Access Compliance Report Public Rights-of-Way (Pedestrian Signals)

Main Street: **NEWPORT_AVE** Cross Street: **EL_CAMINO_LN** Location: **SE**

ADA ID: **SGRK211007131812** Signal Type: **One Push Button-Non APS** Overall Compliance: **No** Severity Scores: **BTN 1: 35** **BTN 2: N/A** **No BTN: N/A**

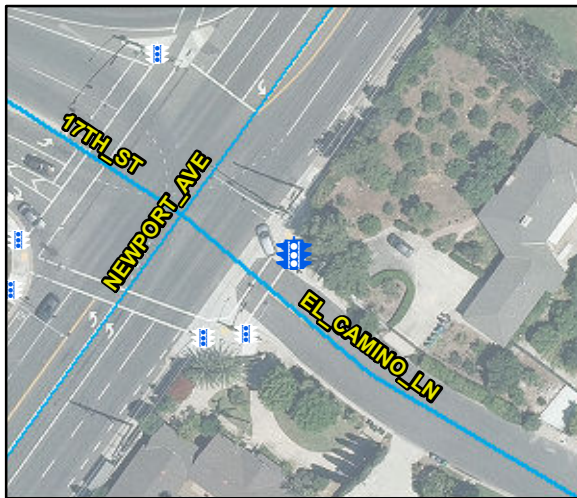
OC Std/PROW: **R404.2, MUTCD 4e.08**

Possible Solutions: Replace Signal Push Button With APS Button. Remove and Replace Clear Space.
